Subject: Response to Remedial Action Design Report  
Spic and Span, Inc. (FMR)  
4301 N. Richards Street, Milwaukee, WI  
DNR BRRTS # 02-41-585636 / FID # 241040690

The Wisconsin Department of Natural Resources (DNR) reviewed the *Remedial Design Report* and the updated Hazardous Waste Determination, dated March 27, 2024 (Report) for the case identified above. The Report was prepared and submitted on your behalf by your consultant, Ramboll Group (Ramboll). The Report was submitted with the applicable technical assistance fee for providing review and response as required under ch. NR 749, Wis. Admin. Code.

**EXC. 1**

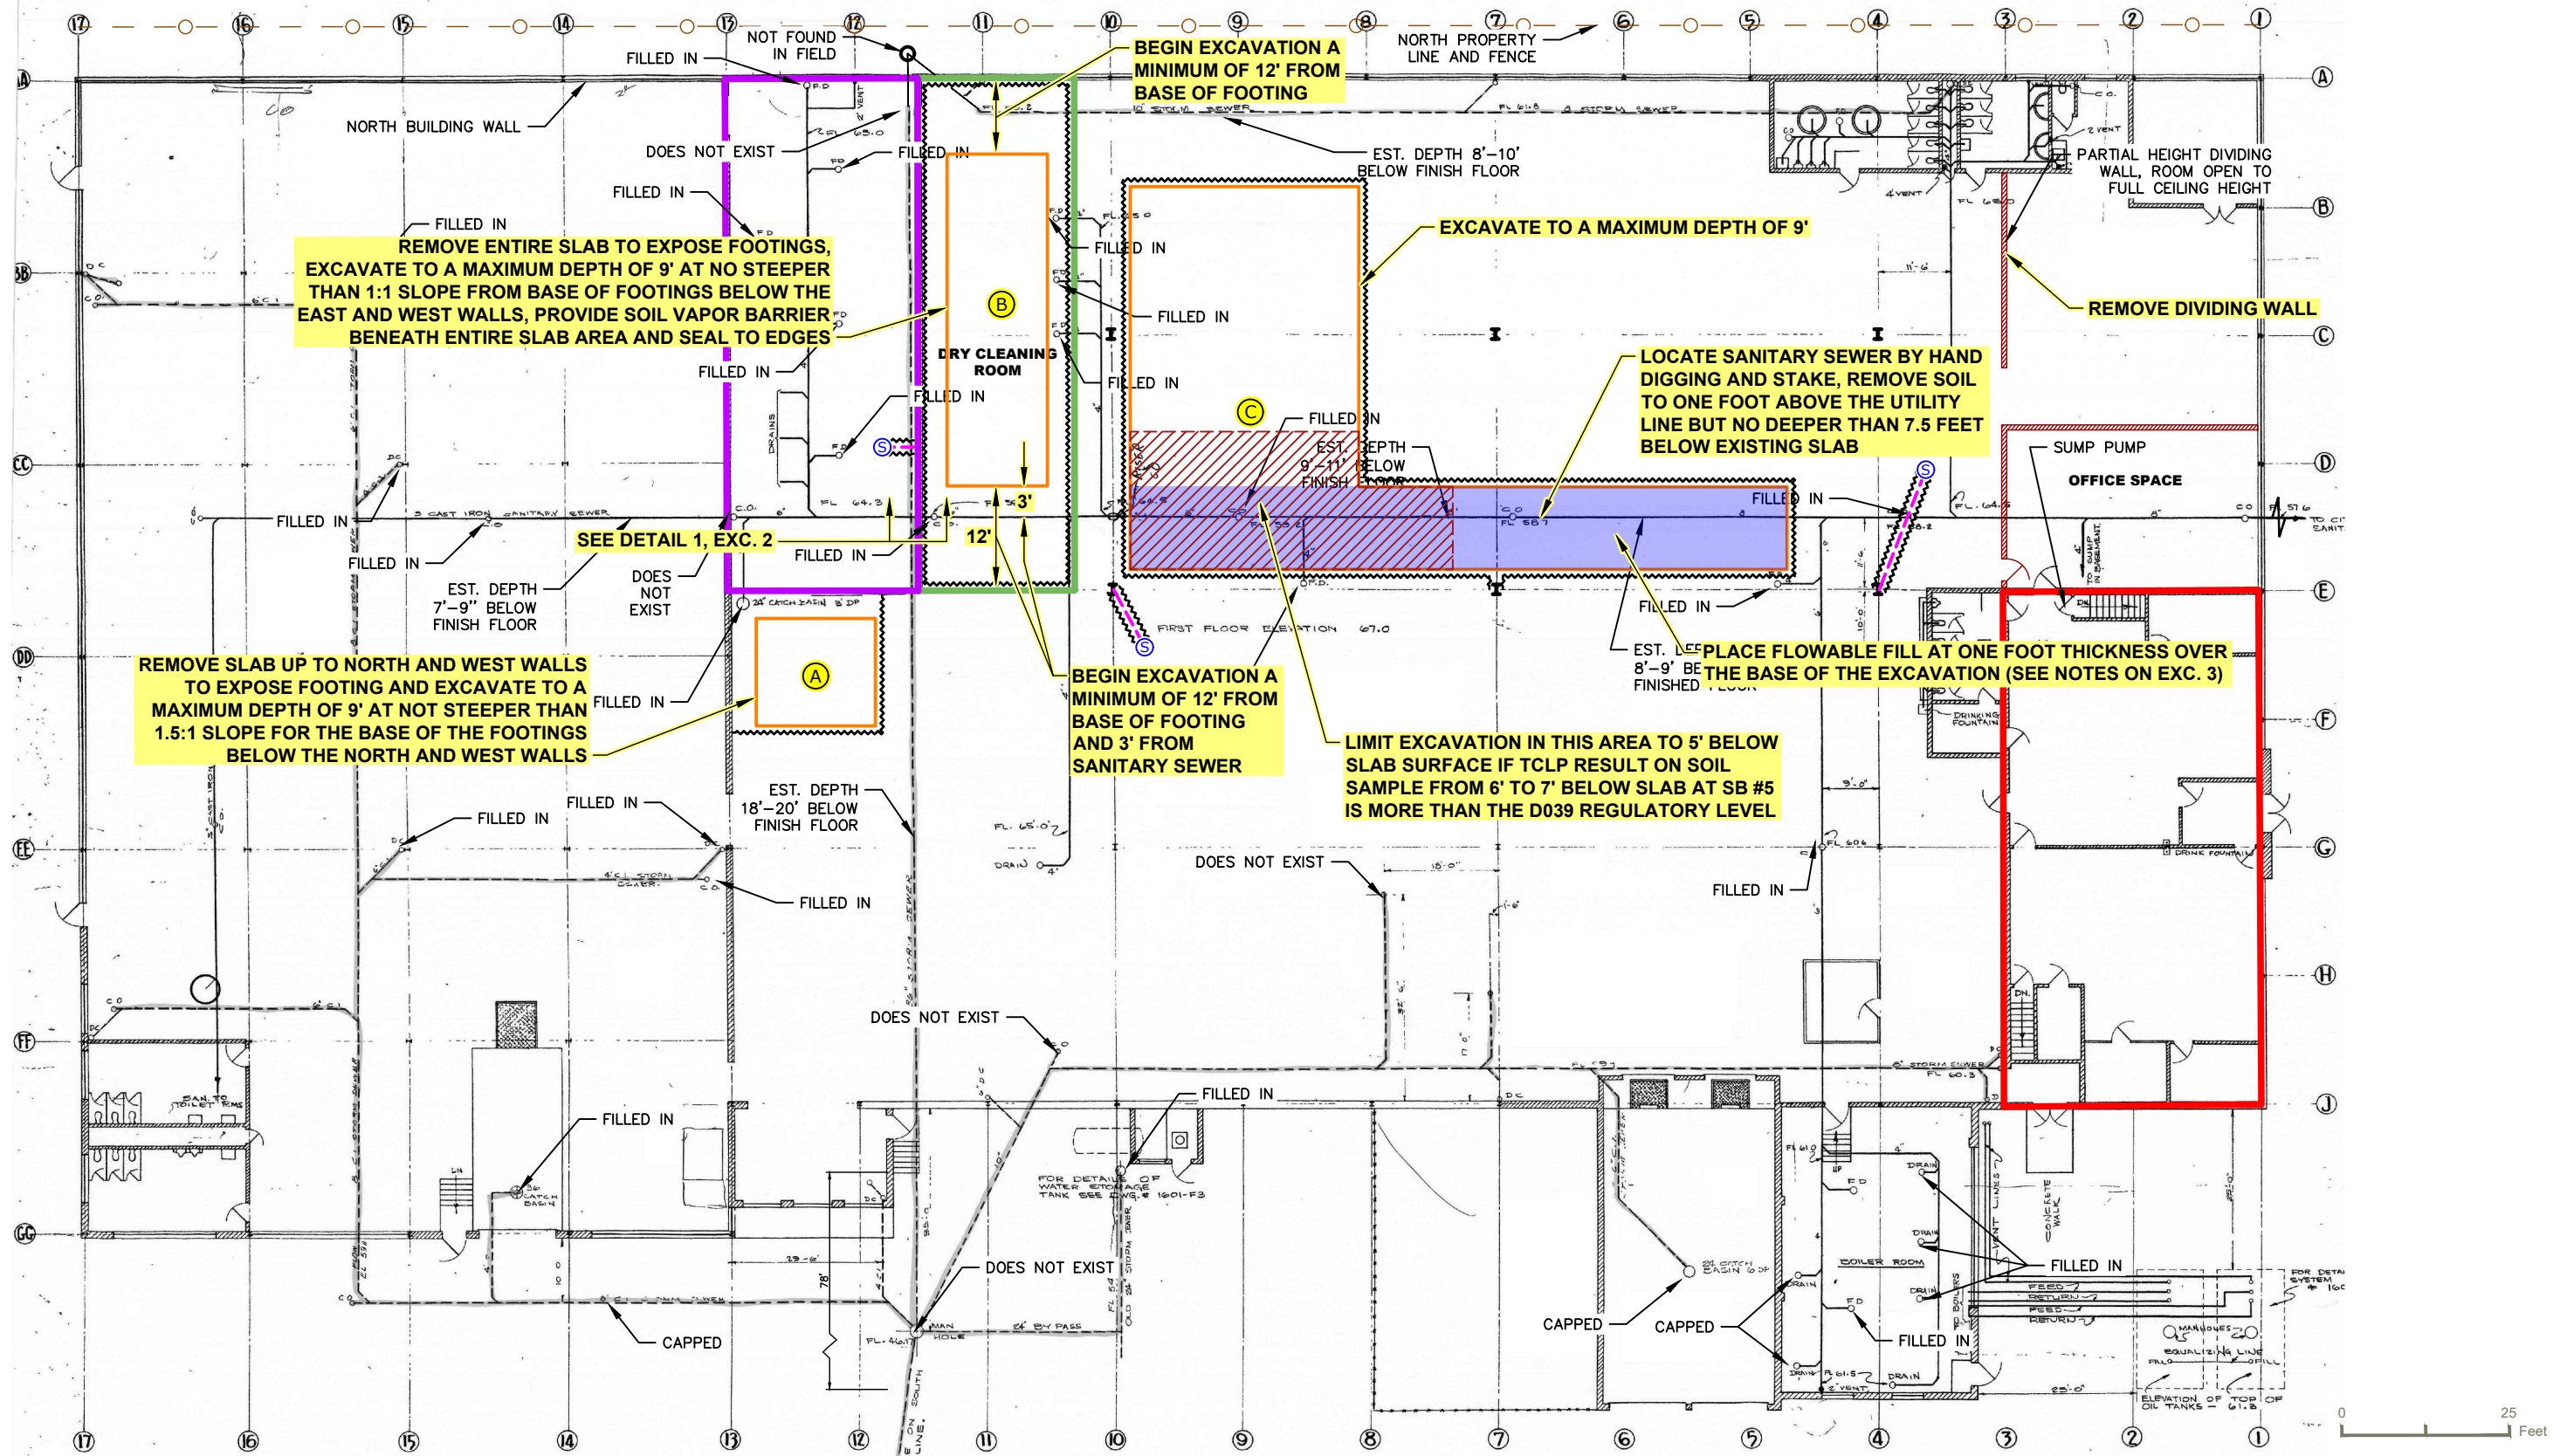
- Estimated depths of excavation in each of the three areas is not shown on Figure 3d as stated. This was provided on drawing Exc. 1 of the Remedial Design Report and is attached for reference.
